# Hampstead Heath Ponds Project

STRATEGIC LANDSCAPE  
ARCHITECT REVIEW

27th October 2013

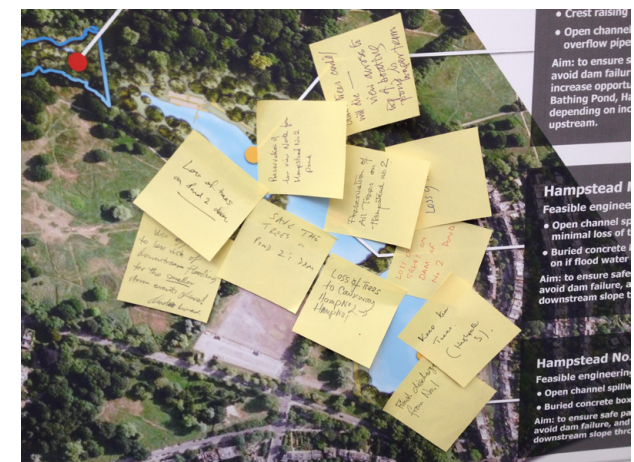
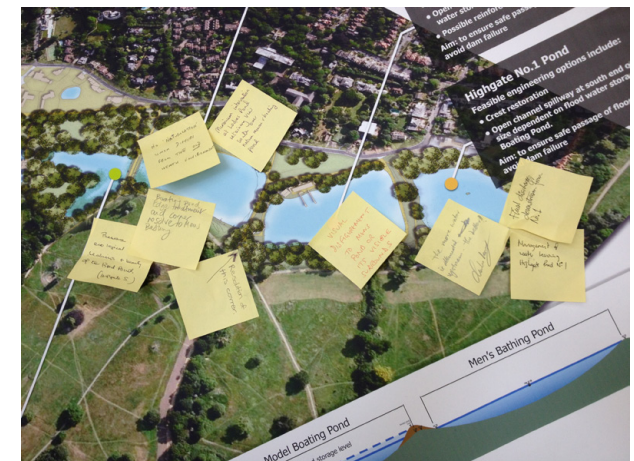
On the 7th June 2013 Atkins issued their draft Constrained Options Report. This report set out for the first time the likely scale of the works at the middle of each pond chain and on the 17th June ranging poles were used to demonstrate the likely scale of the new dam heights proposed at Catchpit and at Model Boating Pond. This exercise was met with a mixed response that ranged from incredulity to acceptance of the scale of works required if the upper and lower ponds were to remain

The general consensus from this exercise was that:

- 3m was too high for the Model Boating Pond
- 5.6m high was acceptable for the Catchpit as long as it was relatively concealed and did not impact on significant trees or views north from the Mixed Bathing Pond.
